**ADDENDUM #1**  
**General Scott Substation Transformer Replacement**  
**26-0004EL**

## **ATTACHMENT 1**

TRANSFORMER Tx. 6912-190-1

**NAME PLATE DATA**  
General Electric  
Load TAP Changing Transformer

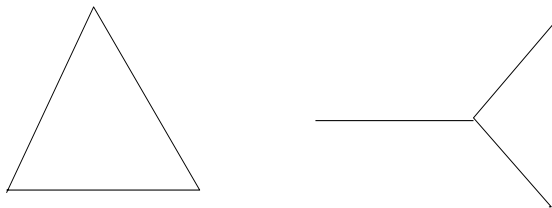
**Q: Please verify the MVA, impedance, BIL rating, CT's, etc. The nameplate pictures are not very clearly readable. If a technical data sheet can be provided that would be very helpful?**

**A: See attachment.**
